TRANS/WP.29/GRSP/2001/3
14 February 2001

World Forum for Harmonization of Vehicle Regulations (WP.29)

PROPOSAL FOR DRAFT AMENDMENTS TO REGULATION No. 29
(Cabs of commercial vehicles)

Transmitted by the Expert from the United Kingdom

Figure 2

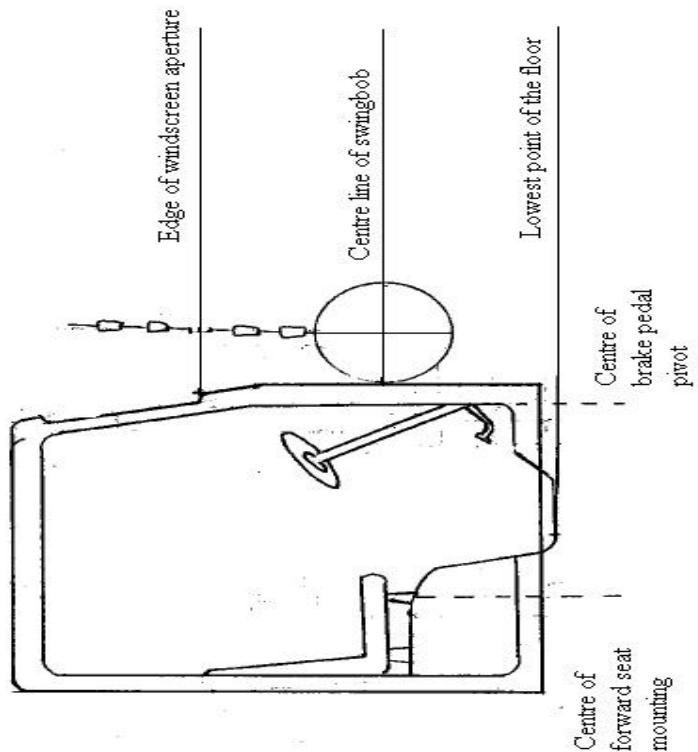
- "4.1.5. The foremost edge of the swing-bob shall strike the cab at a median point between (see figure 2):
- 4.1.5.1. a horizontal plane level with the lowest part of the underside of the drivers floor between:

- 4.1.5.2. a transverse plane passing through the centre of the most forward seat mounting point and a transverse plane passing through the centre of the pivot of the service brake pedal and:

Figure 3

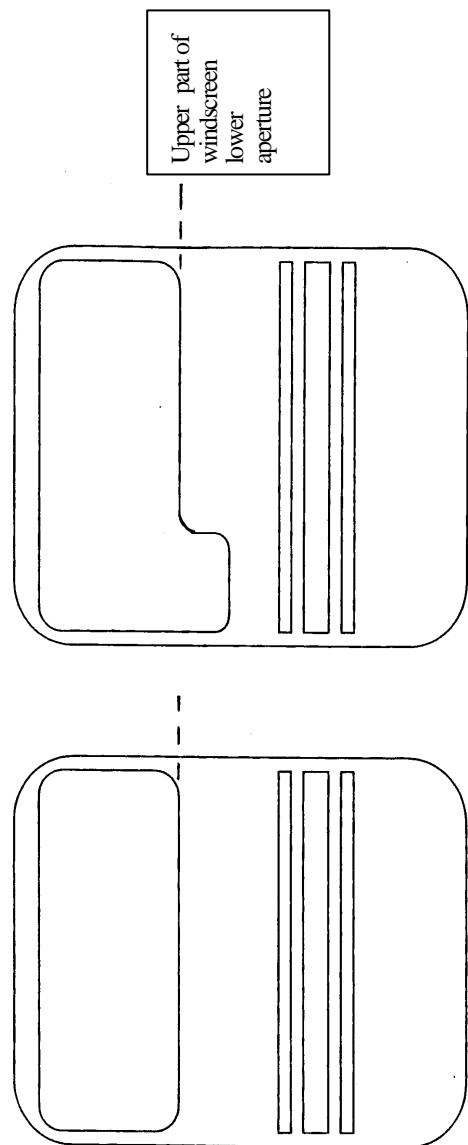
- 4.1.5.3. a horizontal plane level with the lowest part of the lower edge of the windscreen aperture.
- 4.1.5.3.1. If the windscreen is stepped this shall be the longest edge or if an equal split the upper edge (see figures 3a and 3b).

Figure 4

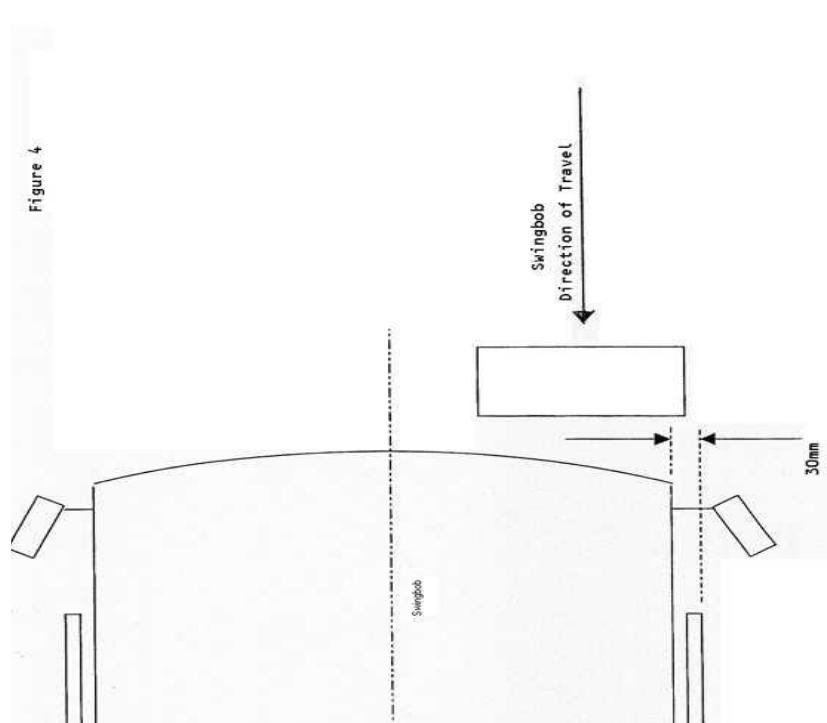
- 4.1.6. The outermost edge of the swing-bob shall be between two parallel vertical planes 30 mm apart, the inner one of which is parallel to the mean longitudinal plane and tangential to the outermost part of the driver's door not including any fitted projections such as, but not limited to, door handles, mirrors and trim (see figure 4)."
